FINAL ENVIRONMENTAL IMPACT REPORT

FOR THE
ANIMAL CONFINEMENT FACILITIES
PLAN, AND DAIRY AND FEEDLOT CLIMATE ACTION PLAN

SCH # 2011111078

August 2017

Fig 3.9-6: Nitrates

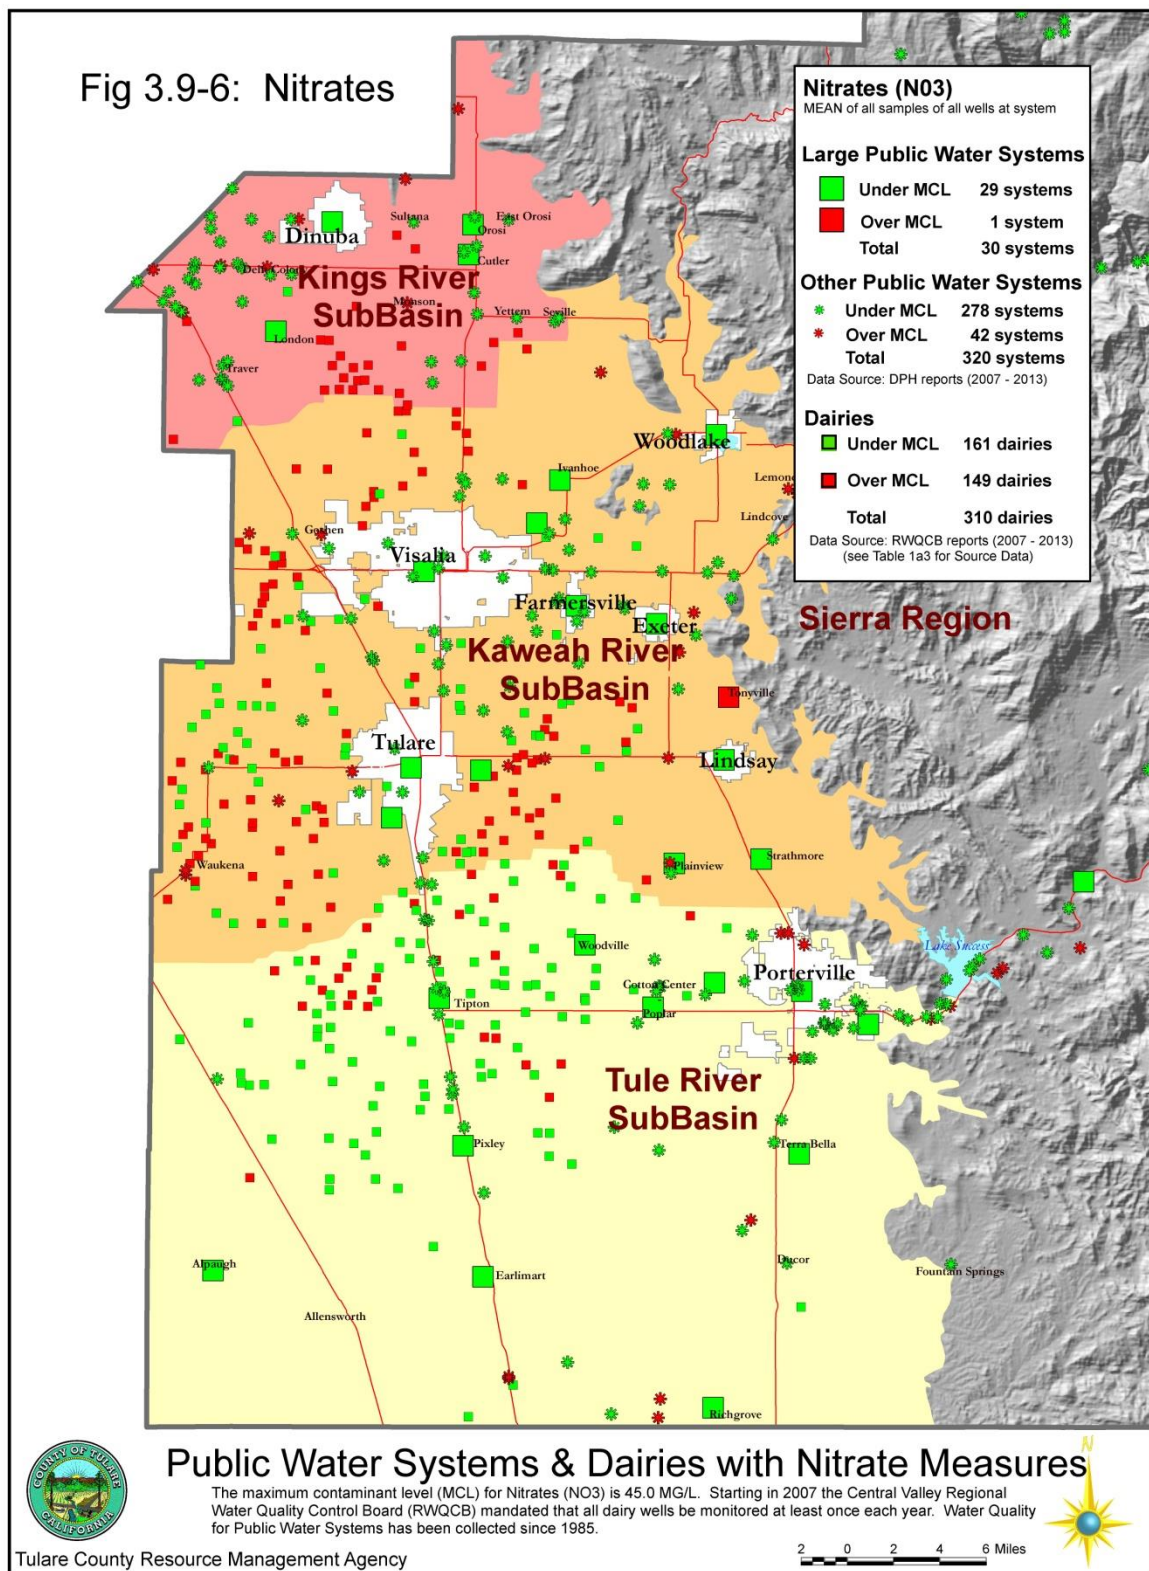
Comment 4a-56: *As a preliminary question, it is confusing why the figures mapping nitrate contamination (EIR Figures 3.9-5 and 3.9-6) look at an MCL of 45 MG/L when the federal MCL is 10 MG/L. Please explain this discrepancy.*

Response: The comment, although addressing the severity of such contamination, does not specify the location of such private wells. Wells in Tulare County have also been impacted by crop fertilization having no association with dairies and their location as illustrated on corrected Figure 3.9-6.
